Exhaust Gas Recirculation (EGR) Valve D11F, D11H, D13F, D13H, D16F, D16H

FSB 293-012, Exhaust Gas Recirculation (EGR) Valve

(October 2012)

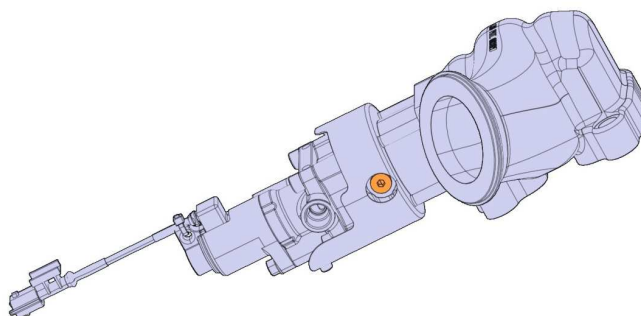
Several improvements in design on the VOLVO D11F, D11H, D13F, D13H, D16F and D16H engines EGR valves allow that they no longer require the drain tube. For D11 and D13 engines, EGR valve replacement kit 85123198 has been replaced by kit 85133799. For D16 engines, 85123199 has been replaced by kit 85135813. When installing the new EGR valve to service a vehicle originally equipped with the drain tube, remove the p-clamp and tube. Discard the old drain tube.

The new EGR valve does not require a drain tube. Do not remove the plug in the new EGR valve and install the drain tube. Damage to components may result.
